Parcel C2a and C2b

DC/21/90474

Further information requested.

Condition 8e – Balcony details

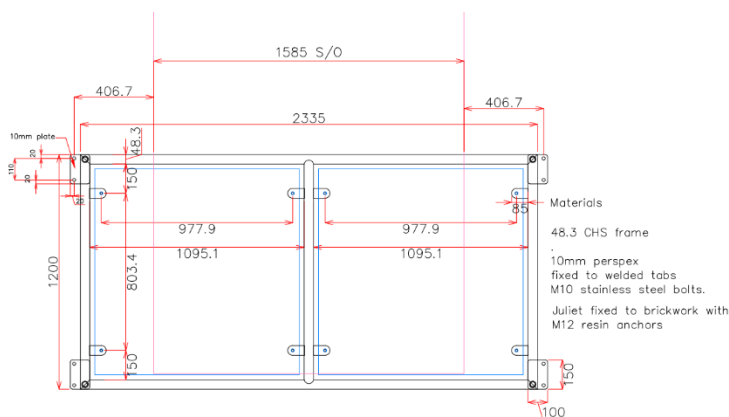
As previously requested, please could you confirm the colour of the balcony frame used for the Juliet Balcony detail for Blocks 1 and 2. I note that in answer to this request drawing Ex 106 rev D “Juliet Balcony Details for 1125mm opening” was resubmitted on 7.12.23, but this is for the style of balcony used on plots 188-191, which is different to the style of balcony used on Blocks 1 and 2. The previously submitted drawing BOV1810-43 “Block 1 and 2 – juliets” is the right style of balcony for Blocks 1 and 2 (see extract below), but it does not include details of the colour of the balcony frame. If you are unable to amend the drawing then written confirmation of the colour of the frame, or a photograph would be acceptable.

Drawing BOV1810-43 Block 1 and 2 – juliets has been amended to show the colour of the frame. Please also see image below of the same balcony in-situ.
